Item ID: D206-667-203TRN Accept ***N900040100*** Setup Start ***NS1***
 Revision ID: Stop ***NS2***
 Item Name: Crosstube Turning Detail
 Start Date: 9/23/2015 Start Qty: 1.00 ***1*** Cust Item ID:
 Required Date: 9/23/2015 Req'd Qty: 1.00 ***1*** Customer:
 Reference:

DART AEROSPACE LTD		Work Order:	137026
Description: Crosstube Assembly		Part Number:	D206-667-243
Inspection Dwg: D206-667-243 Rev: C		Page 1 of 2

DRAWING NO. D206-667-243	TITLE CROSSTUBE ASS'Y (206L HIGH AFT)	REV. C	DART AEROSPACE LTD ENGINEERING ORDER		D.E.O. NO. D206-667-243-C-1	SHEET NO. SHEET 1 OF 1	SCALE NTS
DRAWN <i>q</i>	CHECKED <i>ASS</i>	MFG. APPR. <i>RB</i>	APPROVED <i>MP</i>		DE APPR. <i>#</i>		
DATE 11.07.15	DATE 11.07.20	DATE 11.07.21	DATE 11/07/21		DATE 11.07.21

REPLACE MAGNOBOND WITH PROSEAL.

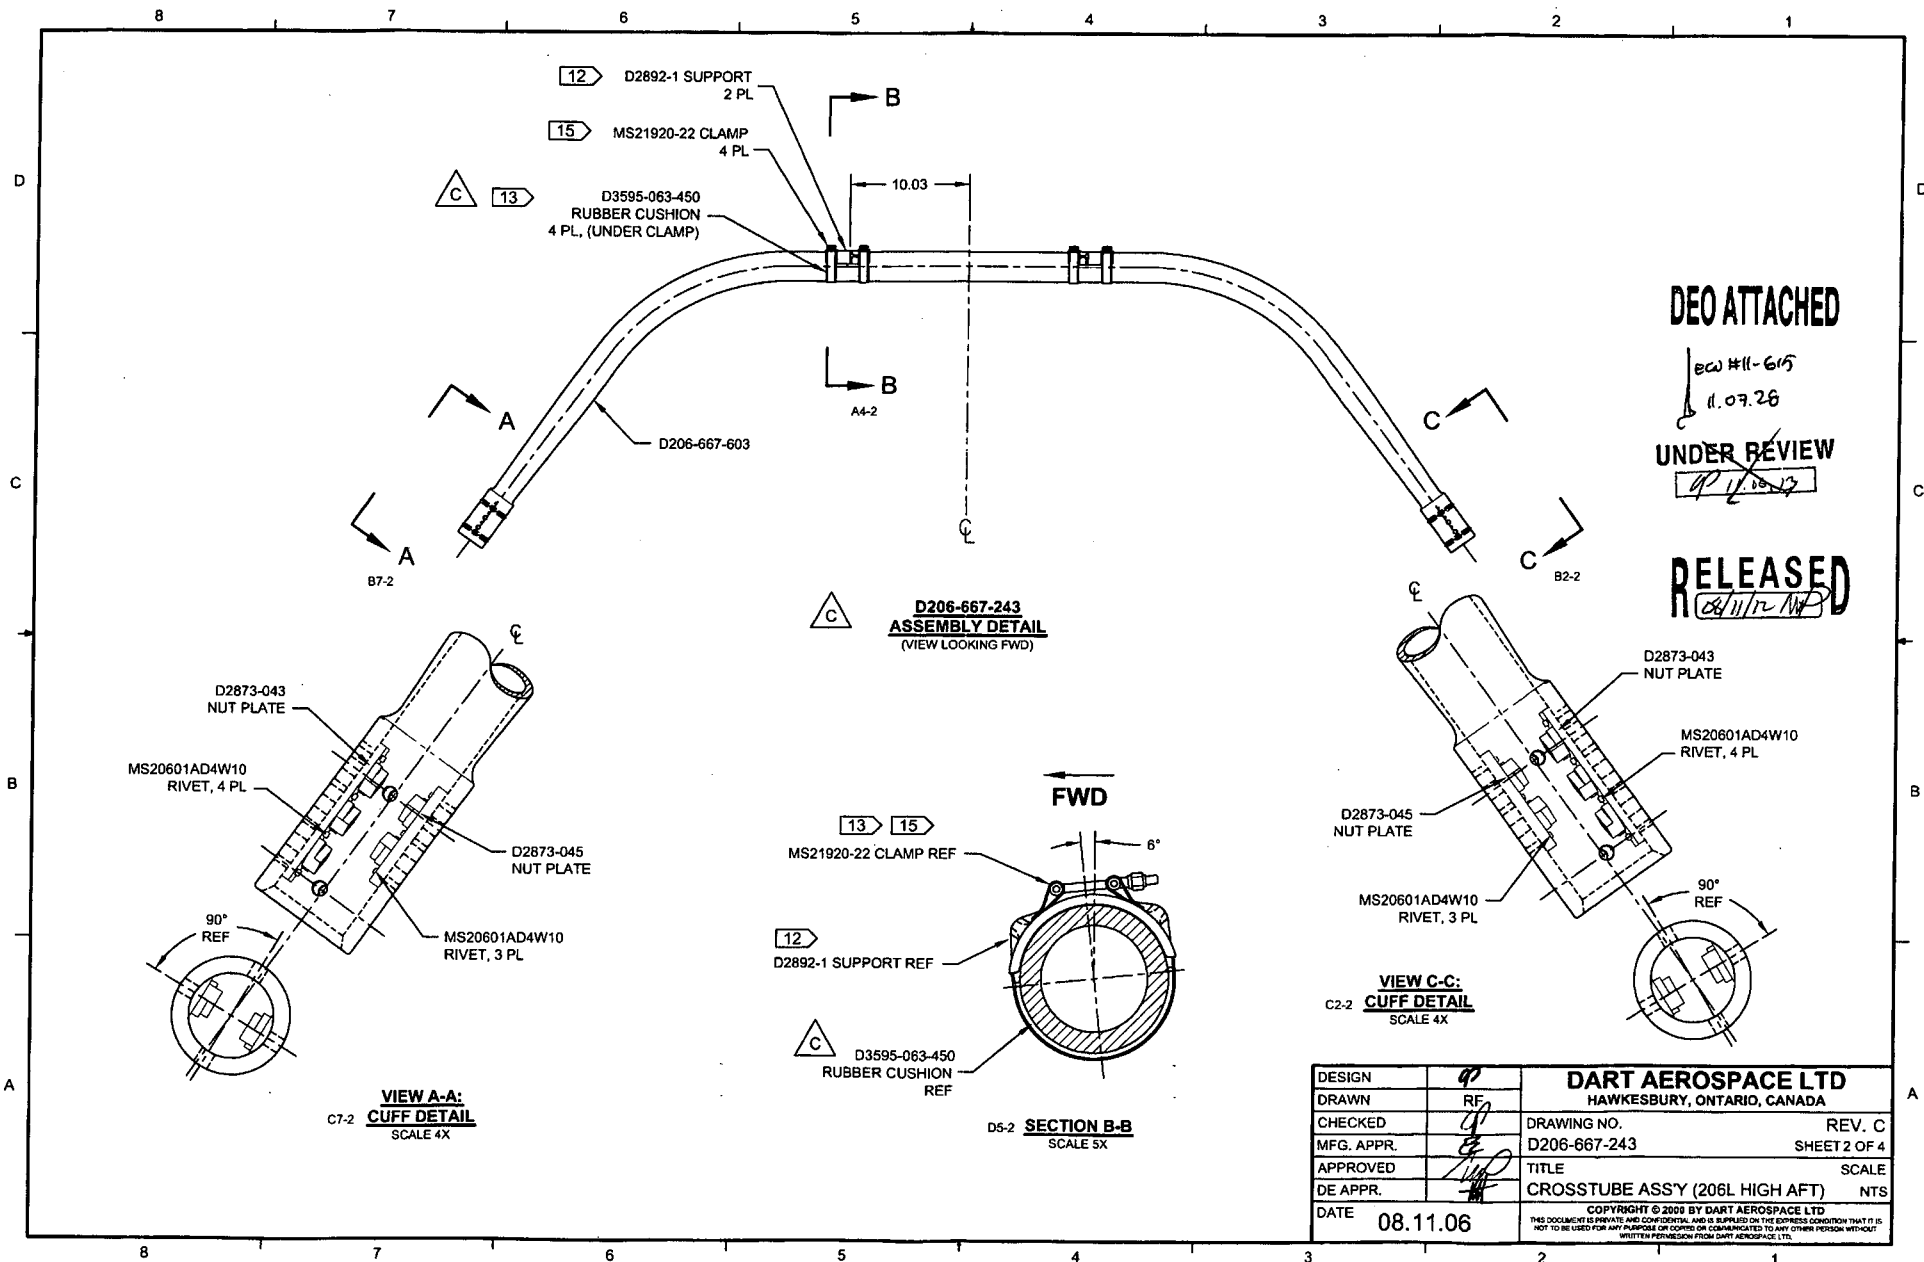
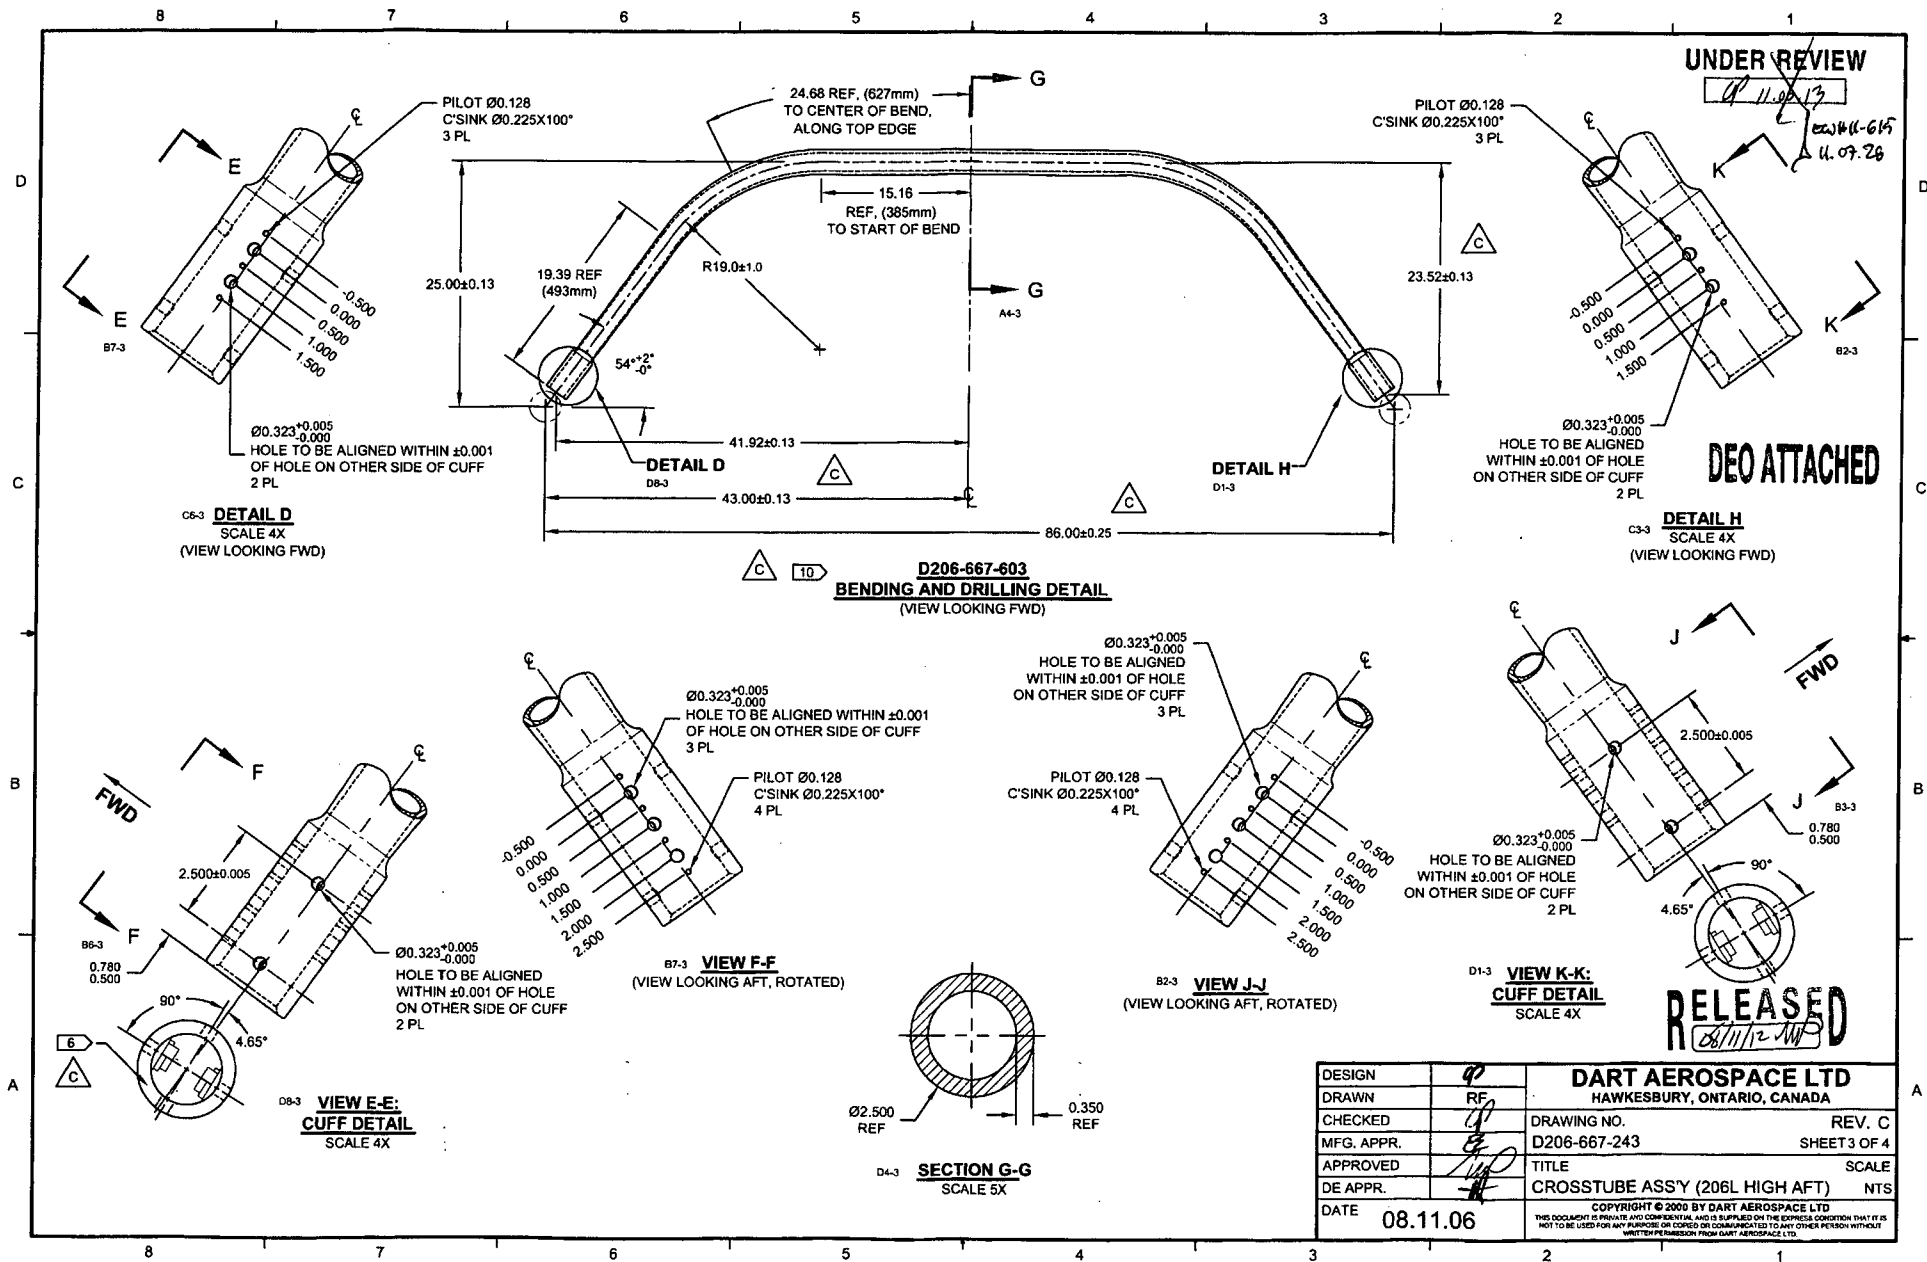
C	REVISE GENERAL NOTES/PART LIST (ZN D7-1); REORGANIZED VIEWS AND REFORMATTED DRAWING TO CURRENT STANDARDS. D3595-063-450 WAS D2858-400-773 (ZN D6-2 & A5-2); REMOVED REF: & ADD TOLERANCES (ZN 4-3, C5-3, D3-3); RELOCATED FLAG #6 (ZN A8-3) PER NCR 210; MOVED TURNING DETAIL & UPDATED TOLERANCE TO SHEET 4.	RF	08.11.06
B	ADD HOLES AND NUT PLATES FOR COMPATABILITY WITH BHT/AA SKUDTUBES	PH	05.07.26
A	NEW ISSUE	CP	00.11.17
REV.	DESCRIPTION	BY	DATE
DESIGN	RF	DART AEROSPACE LTD HAWKESBURY, ONTARIO, CANADA	
DRAWN	RF	DRAWING NO.	REV. C
CHECKED	RF	D206-667-243	SHEET 1 OF 4
MFG. APPR.	RF	TITLE	SCALE
APPROVED	RF	CROSSTUBE ASS'Y (206L HIGH AFT)	NTS
DE APPR.	RF	COPYRIGHT © 2000 BY DART AEROSPACE LTD THIS DOCUMENT IS PRIVATE AND CONFIDENTIAL AND IS SUPPLIED ON THE EXPRESS CONDITION THAT IT IS NOT TO BE USED FOR ANY PURPOSE OR DISCLOSED OR COMMUNICATED TO ANY OTHER PERSON WITHOUT WRITTEN PERMISSION FROM DART AEROSPACE LTD.
